Letter RO-1 – Sierra Club

Figure 1
Project Site Plan

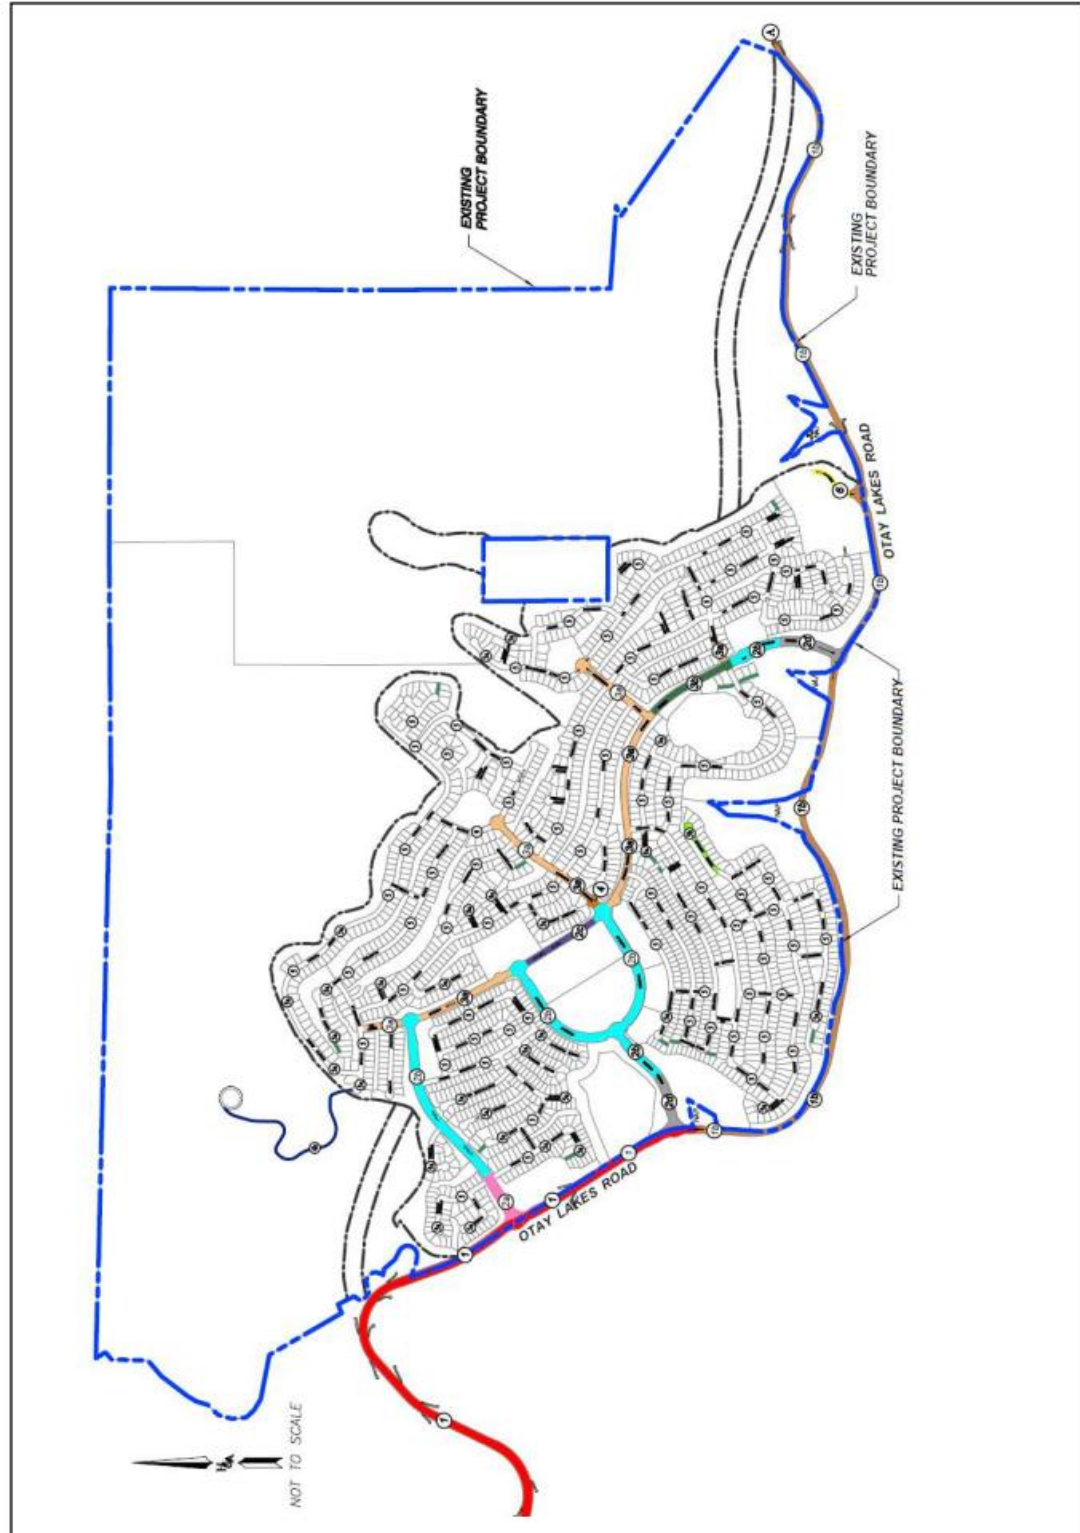
The VMT per capita analysis presented above provides a snapshot of the VMT per capita associated with the proposed Project/Alternative H. However, both the proposed Project and Alternative H would be developed as part of the Otay Ranch General Development Plan (GDP) sub-region approved by the City of Chula Vista and County of San Diego as part of the Sub-Regional Plan (SRP) on October 28, 1993. The Otay Ranch GDP land uses are predominantly made up of suburban densities and are similar to the proposed Project and Alternative H land uses. Since both the proposed Project and Alternative H would be part of the larger SRP with a mix of uses, it also is appropriate to evaluate the proposed Project and Alternative H VMT per capita as part of the Otay Ranch GDP as a whole. Figure 1 displays the full Otay Ranch GDP area, as compared to the San Diego Region.
